EN 1991-1-4:2005/AC

January 2010
Janvier 2010
Januar 2010

Eurocode 1: Actions on structures - Part 1-4: General actions - Wind actions

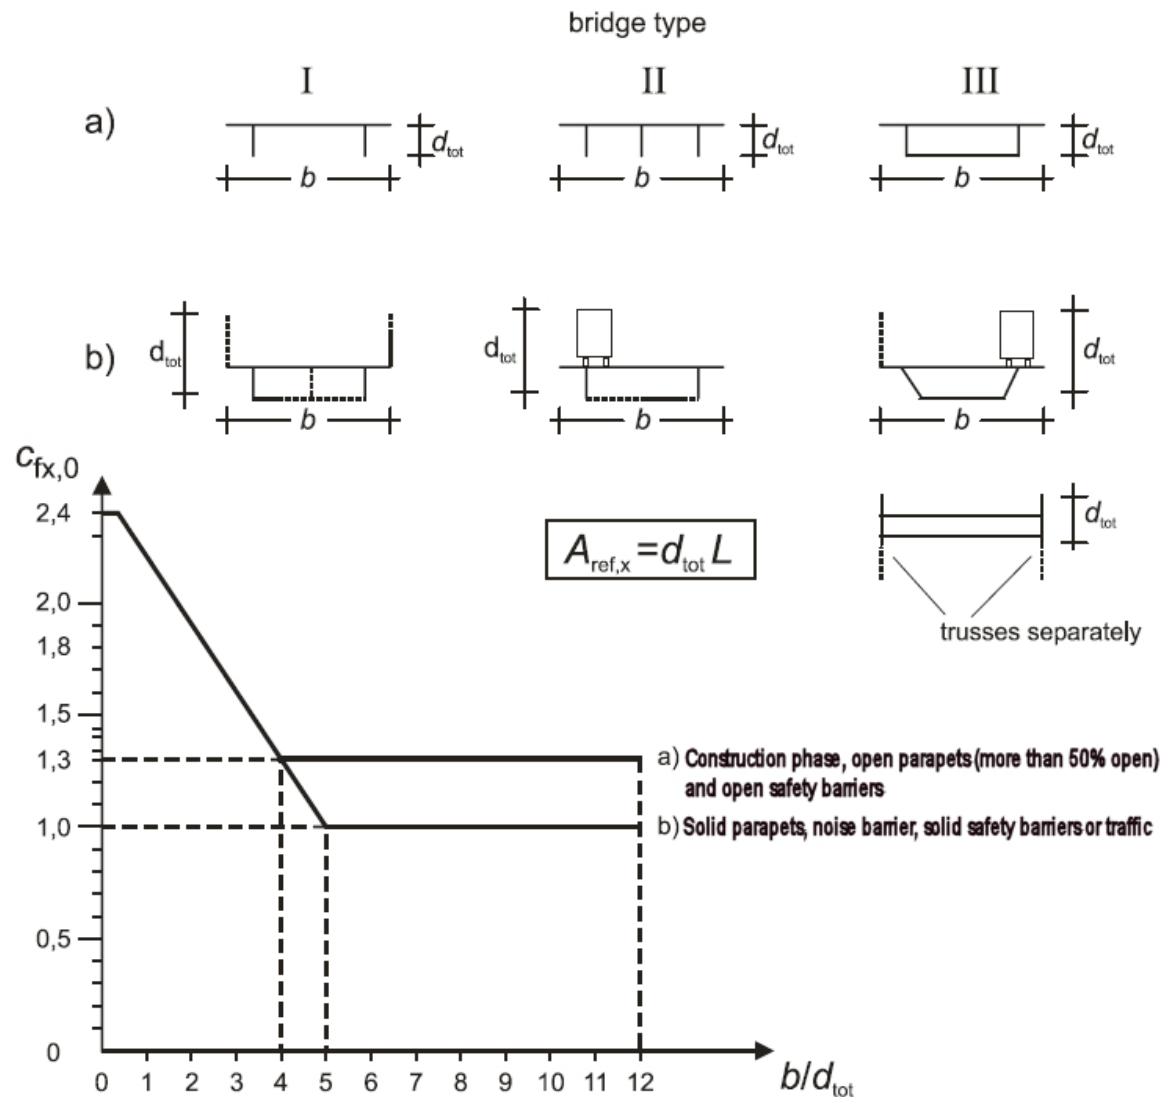
Page 86, paragraph (1), Figure 8.3, replace the notes within the figure:

"a) construction phase or open parapets (more than 50% open)

b) With parapets or noise barrier or traffic"

with:

"a) Construction phase, open parapets (more than 50% open) and open safety barriers

b) Solid parapets, noise barrier, solid safety barriers or traffic"

a) Construction phase, open parapets (more than 50% open) and open safety barriers
b) Solid parapets, noise barrier, solid safety barriers or traffic
